Attachment II

Marked up copy of R.E. Ginna Nuclear Power Plant  
Technical Specifications

3.7.12 Spent Fuel Pool (SFP) Boron Concentration

3.7.13 Spent Fuel Pool (SFP) Storage

Figure 3.7.13-2  
Fuel Assembly Burnup Limits in Region 2

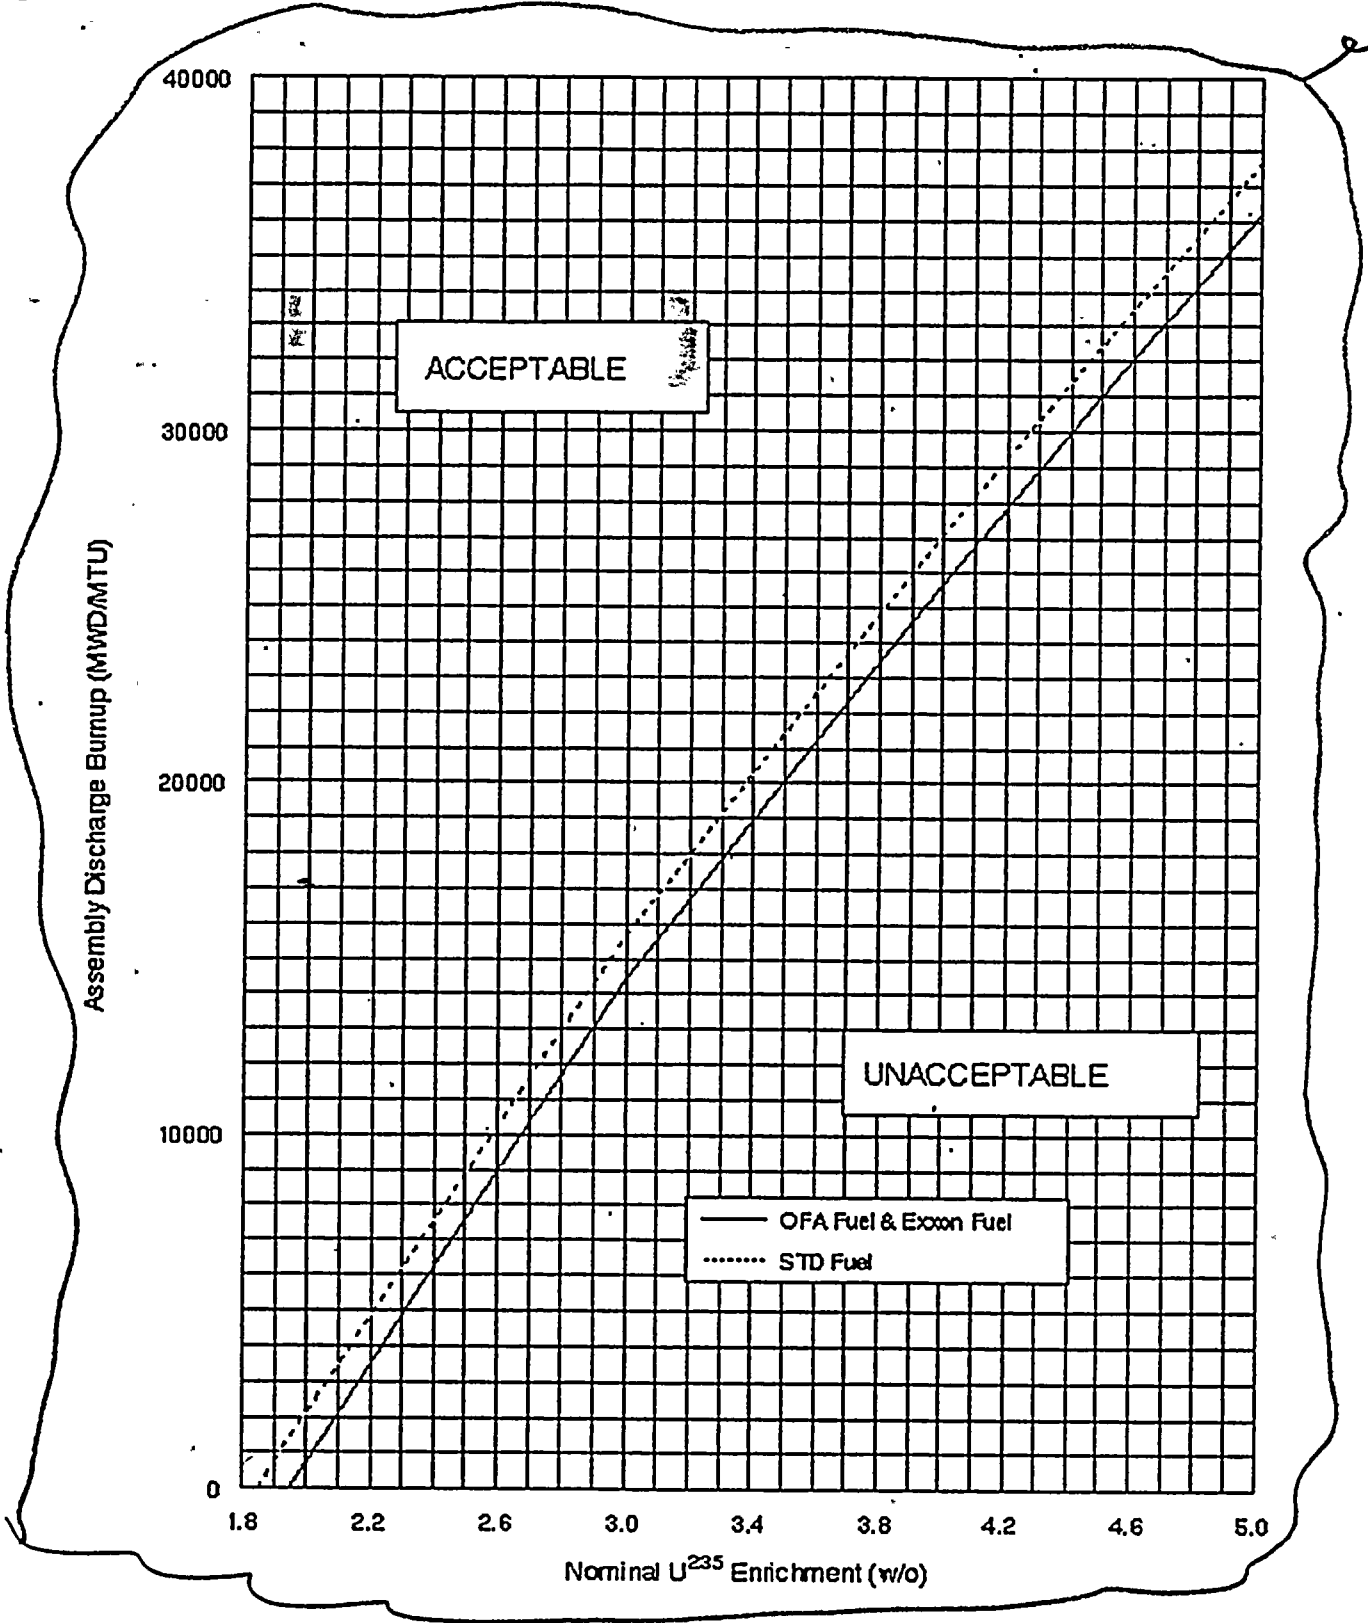
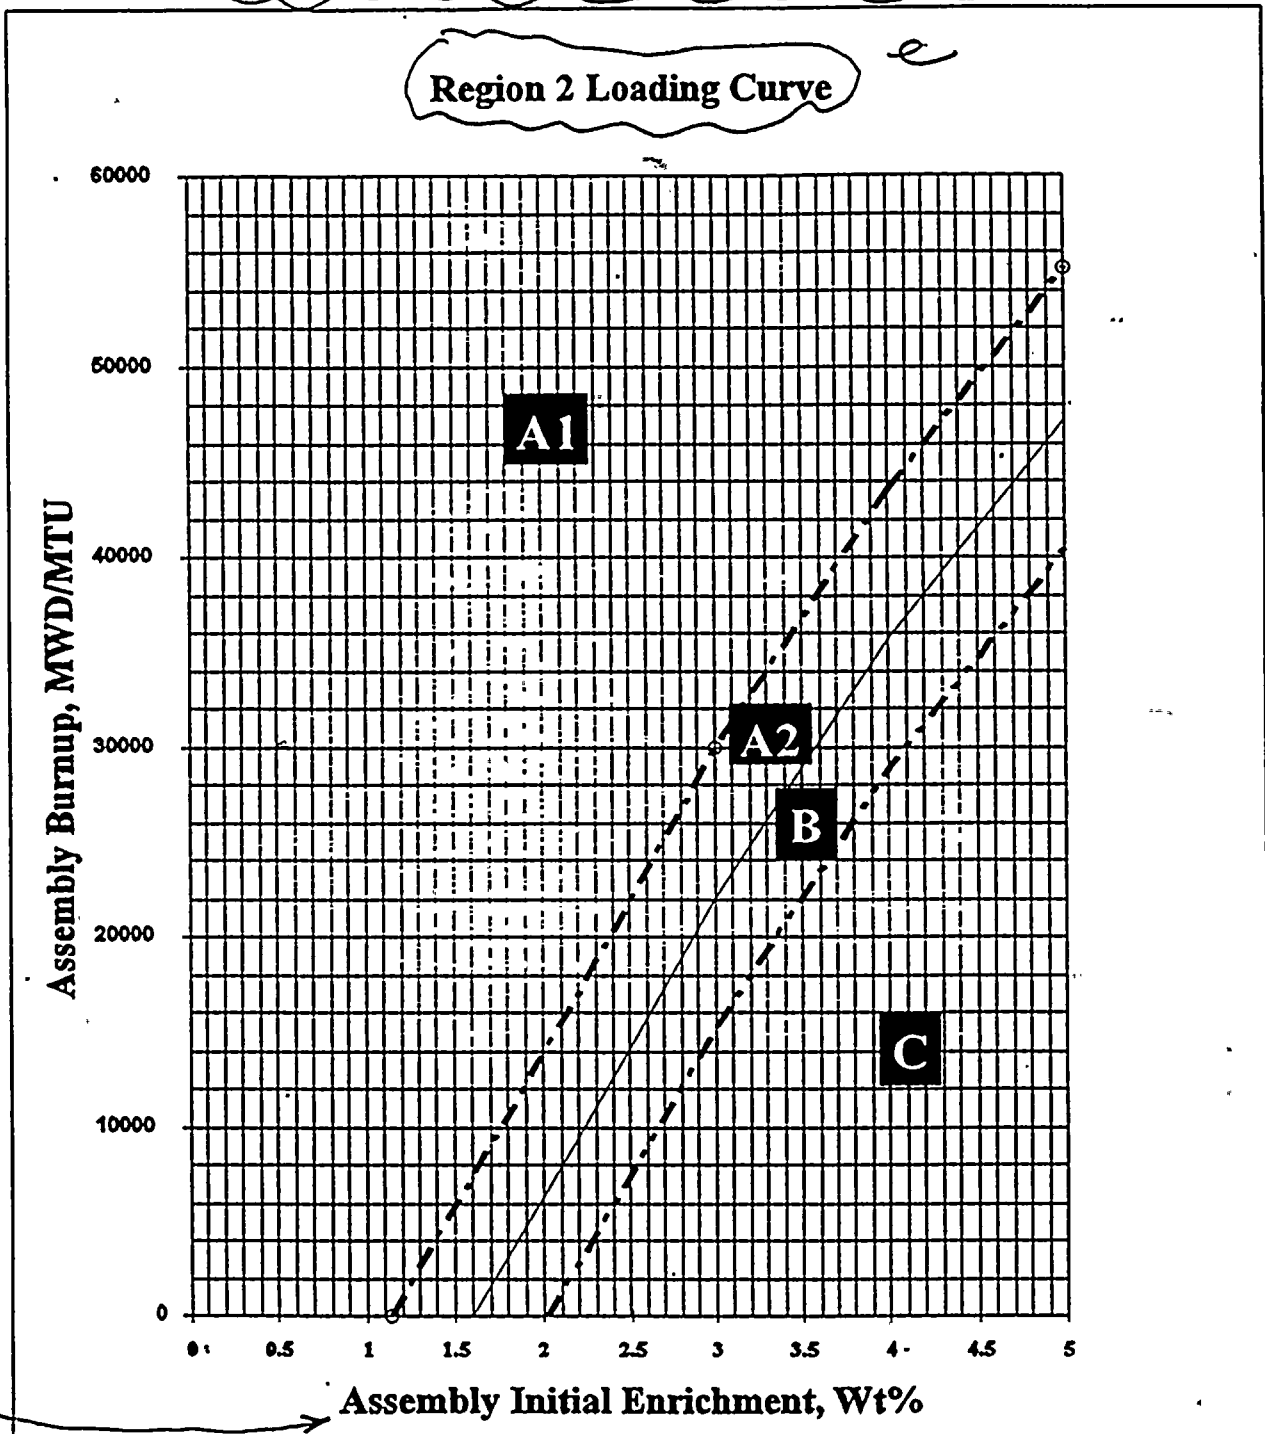
Insert new Figures  
3.7.13-1 and 3.7.13-2

Figure 3.7.13-<sup>2</sup>  
Fuel Assembly Burnup Limits in Region 2

- A1 - Acceptable burnup domain for storage in any location within Region 2.
- A2 - Acceptable burnup domain for storage face-adjacent to a Type A1 or A2 assembly, or a water cell.
- B - Acceptable burnup domain for storage face-adjacent to a Type A1 assembly or a water cell.
- C - Acceptable burnup domain for storage face-adjacent to a water cell only.

For fuel assemblies stored in Region 2, initial enrichment and burnup shall be within the acceptable area of the Figure 3.7.13-2. The x-axis of Figure 3.7.13-2 is the nominal U-235 enrichment wt% which does not include the  $\pm 0.05$  wt% tolerance that is allowed for fuel manufacturing and listed in Specification 4.3.1.1.

Figure 3.7.13-1  
Fuel Assembly Burnup Limits in Region 1

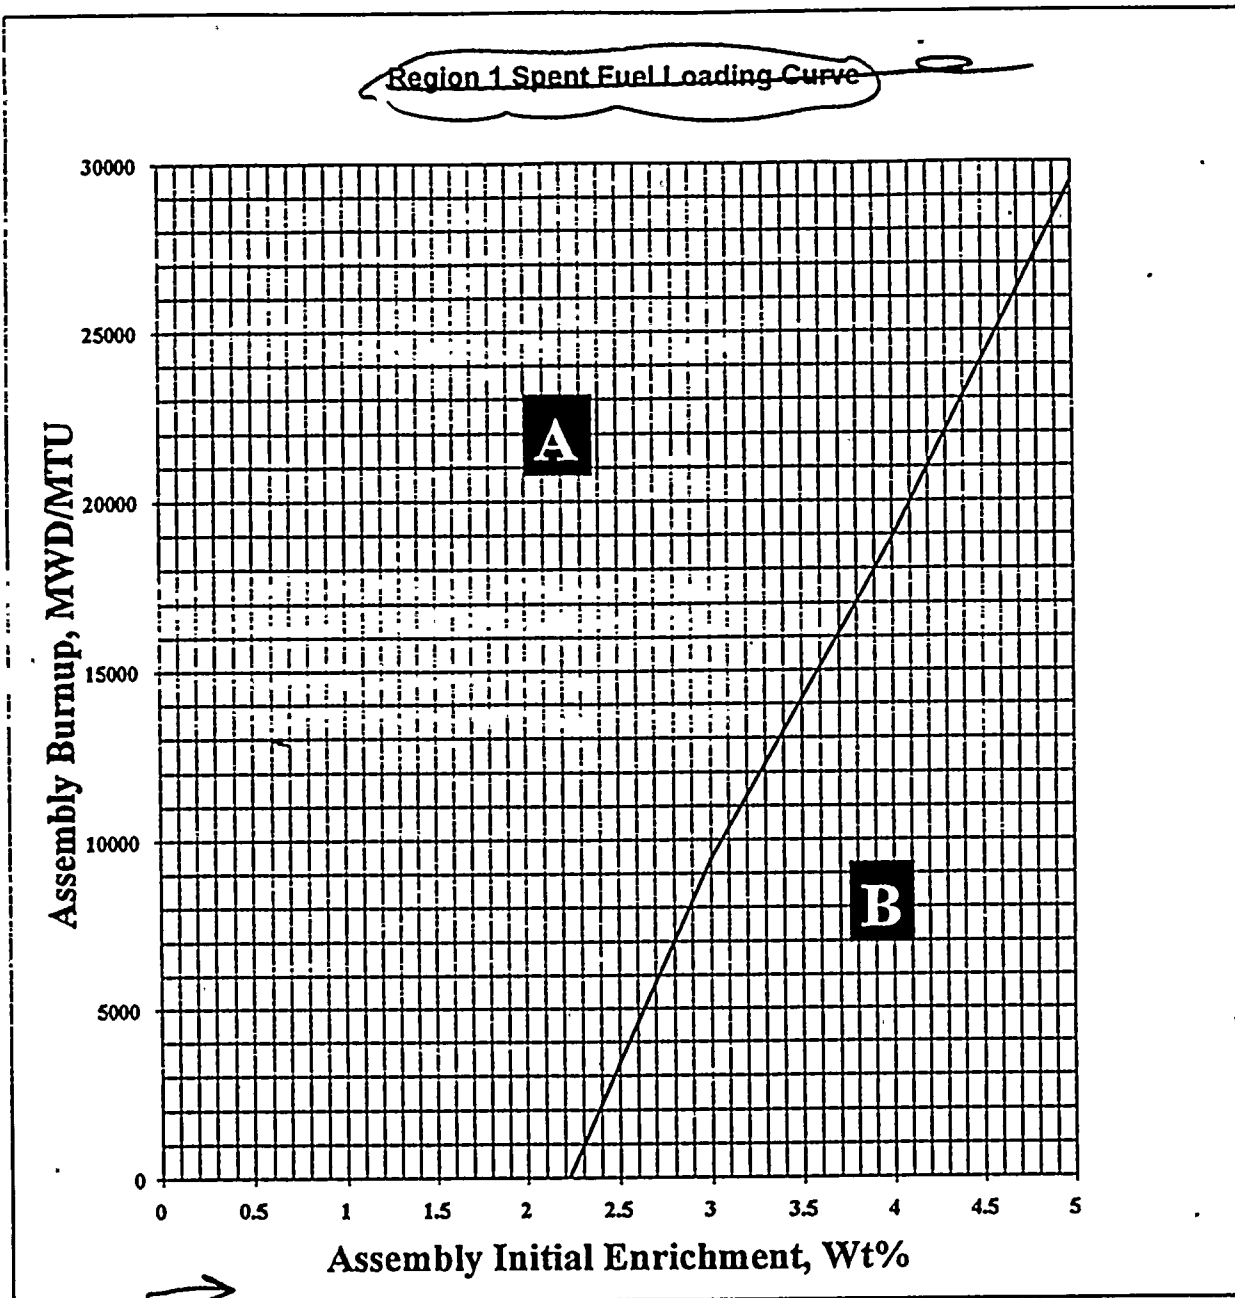
and shall have initial enrichment and burnup within the acceptable area of Figure 3.7.13-1

- A - Acceptable burnup domain for storage in any location within Region 1.
- B - Acceptable burnup domain for storage in cells with lead-in funnels only.

Figure B 3.7.13-1  
Spent Fuel Pool

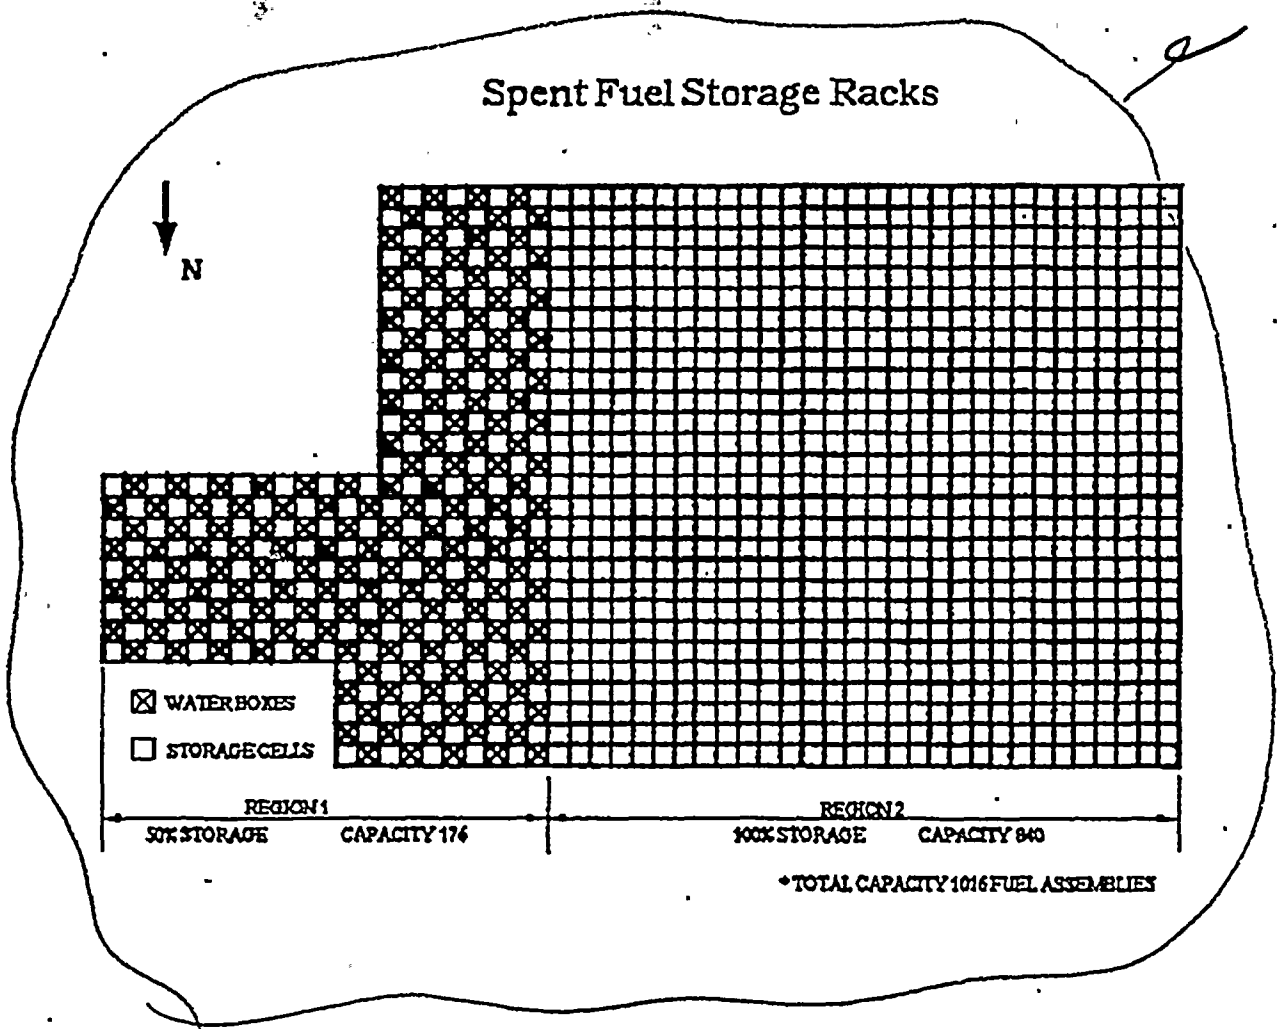
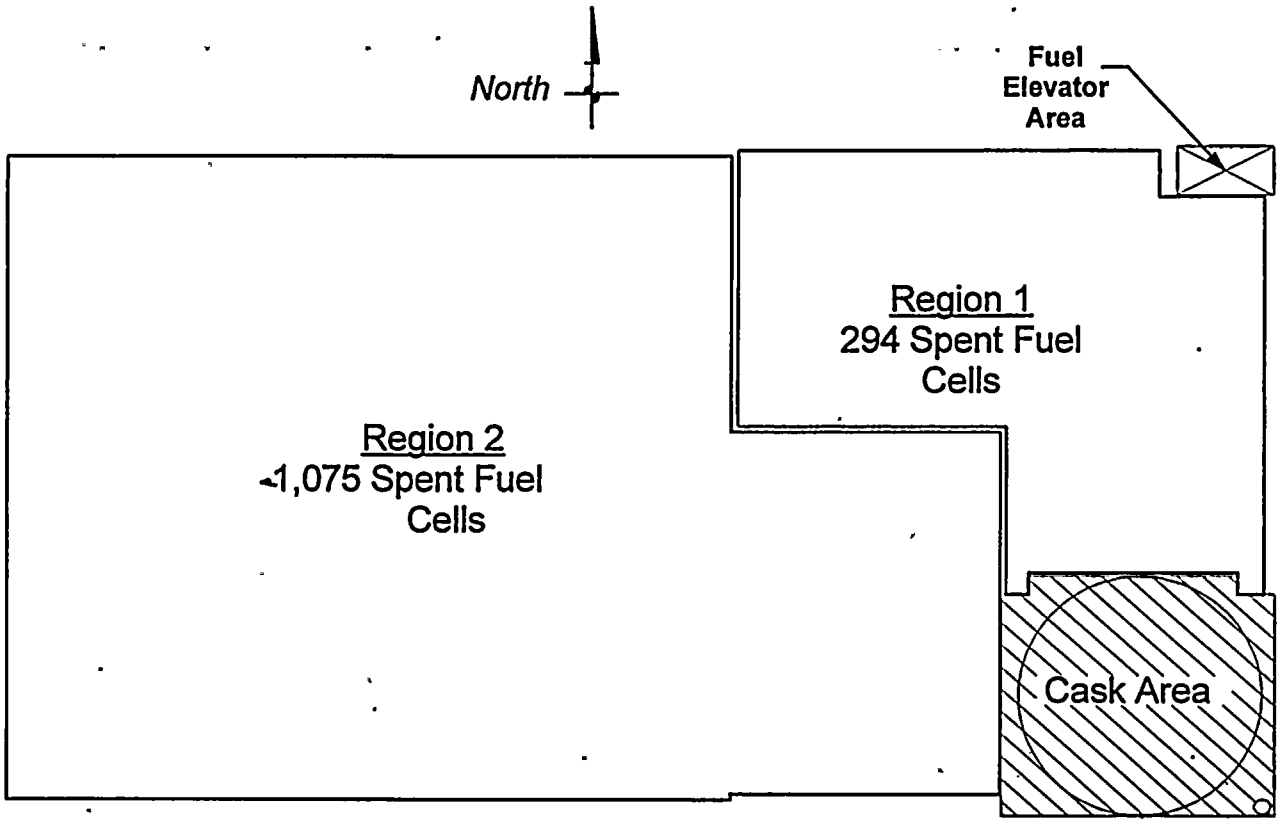
replace
